January 6, 2020

**RE: Comments on the Draft Environmental Impact Report for Operations of the State Water Project**

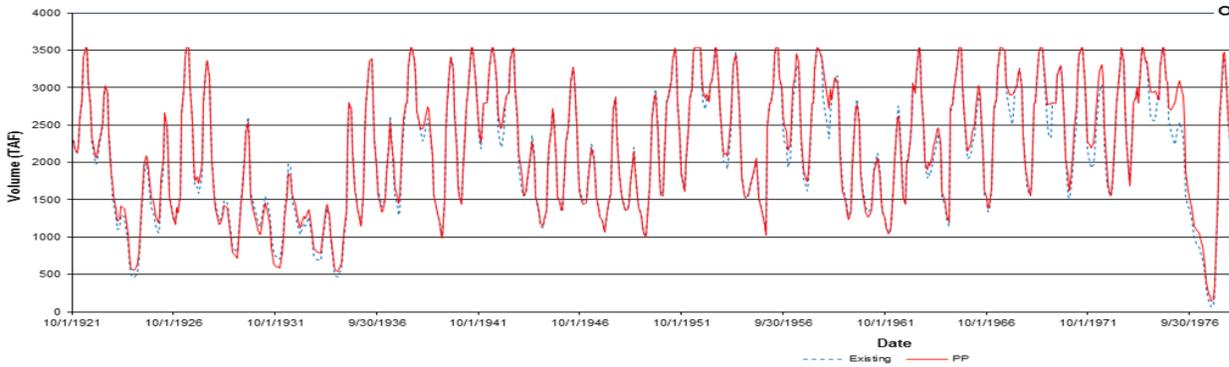
Reclamation's Environmental Assessment found that implementing the COA Addendum would cause storage in Lake Oroville to be lower in below normal (1% decline), dry (2.9% decline), and critically dry water year types (6.5% decline). *See* Bureau of Reclamation, Environmental Assessment, Addendum to the Coordinated Operating Agreement, Central Valley Project/State Water Project, December 2018.<sup>13</sup> Similarly, staff with the USFWS have indicated that CalSim modeling shows that implementing the Addendum to the COA contributes to storage in Lake Oroville dropping to unmanageable and unrealistically low levels during droughts. *See* email from Derek Hiltz to Doug Obegi dated March 29, 2019, which is attached hereto as Exhibit 1. Oroville storage has never historically been drawn below 882,000 acre feet, yet this modeling shows that Oroville storage would be drawn far below this level.<sup>14</sup> While the DEIR fails to include modeling of upstream effects generally, DWR's CalSim modeling outputs for the proposed project that were provided to NRDC show that reservoir storage in Lake Oroville is drawn to dramatically low levels in most major droughts, as shown in the figure below.

<sup>14</sup> It appears that DWR could not release water from Oroville Reservoir at the rates and amounts modeled by CalSim at these low storage levels. Moreover, DWR's implementation of the COA Addendum would contribute to significant adverse environmental impacts, such as impacts on salmon and other fish species in the Feather River caused by high temperature of water released from Oroville under such storage levels. None of these impacts are analyzed in the DEIR.

These modeling results, which are not disclosed or discussed in the DEIR, are consistent with the analysis by staff from the USFWS.

DWR has a duty to disclose the effects of the Addendum to the COA, including these significant adverse effects. DWR has not complied with its NOP, and DWR must revise the NOP and/or revise the DEIR to analyze the effects of implementing the addendum to the COA.
